**MicroNest: Located at 195 – 197
Sydney Road, Fairlight**

BCA Assessment Report Report 2020/1802 R1.0

**Prepared for Construction Assignments
November 2020**

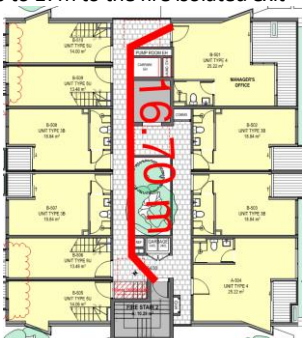
3.	Clause D2.20	<p>The following doors swing in a direction that impedes on occupant evacuation.</p>   <p>The following door requires adequate clearances provided to utilise the door</p> 	<p>The doors to the left are required to be reswung or altered in the design so as to swing in the direction of occupants evacuating the premises or clearance is provided. A copy of amended drawings demonstrating compliance are required to be issued to the certifying authority for review</p>

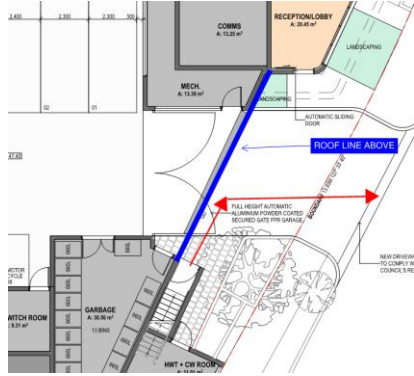
Item	DTS Clause	Description of Non-compliance	Requirement to Satisfy BCA
4.	Clause F4.8	<p>The accessible facility currently located within the confines of the level 1 communal kitchen facility opens directly into a premises which will under use be occupied by more than 1 person.</p> 	<p>A design which documents a means of separation as listed under BCA Clause F4.9 is required to be implemented on amended drawings issued to the certifying authority for review.</p> <p>Requirements of Clause F4.9</p> <p>If a sanitary compartment opens directly into a space, which is occupied by more than one person one of the following is required to be installed / implemented:</p> <ol style="list-style-type: none"> 1. Implementation of an airlock, hallway or other room with a floor area of not less than 1.1m² and fitted with self-closing doors; or 2. The sanitary compartment must be provided with mechanical exhaust ventilation and the doorway serving the room adequately screened from view

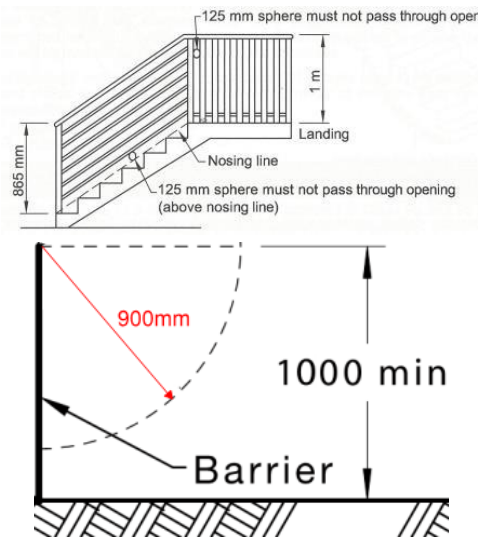
Clause	Description	Comment	Status
	Every stair in a Class 5 to 9 building must be fire isolated unless it does not connect or pass through more than 3 consecutive floors in a sprinkler protected building, or 2 storeys in a non-sprinkler protected building.	are considered isolated for the purposes of evacuating occupant safely to the road and / or open space. The shaft housing the fire isolated stairs is required to achieve an FRL of the following unless subject to a performance solution discussed within BCA Clause C2.8, C2.9 and Specification C1.1 <ul style="list-style-type: none">• Class 3 – 90/90/90• Class 7a – 120/120/120	Achievable
D1.4	Exit travel distances No point on the floor must be more than 20m to an exit or a point in which travel in different directions to 2 exits is available, in which case, the maximum distance to 1 exit cannot exceed 40m. (Refer to concession under Spec E1.5a for Class 2 and 3 buildings not more than 25m in effective height with a sprinkler system complying with AS 2118.1 or AS 2118.4)	The following areas have been identified with distances exceeding 12m to a point of choice: 2. Level 5 – Up to 17m to the fire isolated exit  4. Level 4 – Up to 15m to the fire isolated exit  5. Level 3 – Up to 16m to the fire isolated exit  6. Level 2 – Up to 18m to the fire isolated exit	Performance Solution

Clause	Description	Comment	Status
		 <p>Details of the above extended travel distances are required to be assessed through the projects fire engineer to determine the feasibility of undertaking a performance solution</p>	
D1.5	Distance between alternative exits		Complies
D1.6	Dimensions of exits and paths of travel to exits		Complies
D1.7	Travel via fire-isolated exits	<p>The provided fire isolated stairs which service the development pass by unprotected openings proposed within the development. The discharge onto the driveway past the gates is to be considered as a performance solution and addressed through the projects fire engineer.</p> 	Performance Solution
D1.8	External stairways or ramps in lieu of fire-isolated exits		N/A
D1.9	Travel by non-fire-isolated stairways or ramps		N/A
D1.10	Discharge from exits Suitable barriers such as bollards are to be provided to prevent the blockage of exits by vehicles, etc. An unobstructed path of travel to the road must be provided with a width not less than the width of the required exit.	Details of the methods of protection of the doors are required to be provided on the plans to demonstrate compliance against the requirements of BCA Clause D1.10	Compliance Readily Achievable

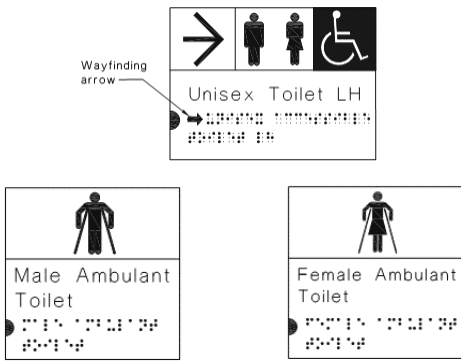
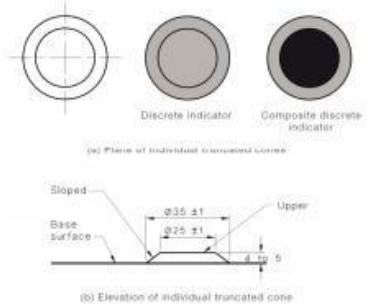
D2.20	<p>Swinging doors</p> <p>Defined exit doors that serve a part of a building with a floor area over 200m² must swing outward in the direction of exit travel.</p> <p>Must not encroach more than 500mm into the required width of the stair or 100mm when fully open and swing in the direction of travel.</p>	<p>The following doors swing in a direction that impedes on occupant evacuation.</p>  <p>COMMUNAL ROOM A: 19.27 m²</p> <p>COMMUNAL KITCHEN A: 17.8 m²</p> <p>HWT + CW ROOM A: 11.01 m²</p> <p>The following door requires adequate</p>	Does Not Comply

Clause	Description	Comment	Status
		<p>clearances provided to utilise the door</p>  <p>The above doors are required to be reswung or altered in the design so as to swing in the direction of occupants evacuating the premises or clearance is provided. A copy of amended drawings demonstrating compliance are required to be issued to the certifying authority for review</p>	
D2.21	<p>Operation of latch</p> <p>Exit doors should be provided with “free handle” egress via a downward or pushing action and, if serving an area accessible to people with disabilities, must have non-slip “D” pull handles with 35-45mm hand clearances.</p> <p>Where the latch operation device is not located on the door leaf itself-</p> <ul style="list-style-type: none"> • manual controls to power-operated doors must be at least 25 mm wide, proud of the surrounding surface and located not less than 500 mm from an internal corner; and • for a hinged door, between 1 m and 2 m from the door leaf in any position; • and for a sliding door, within 2 m of the doorway and clear of a surface mounted door in the open position. • braille and tactile signage complying with Clause 3 and 6 of Specification D3.6 must identify the latch operation device. 	<p>All exit doors and doors in the path of travel must comply.</p>  <p>(a) Isometric view</p>  <p>(b) Plan view</p>	Compliance Readily Achievable
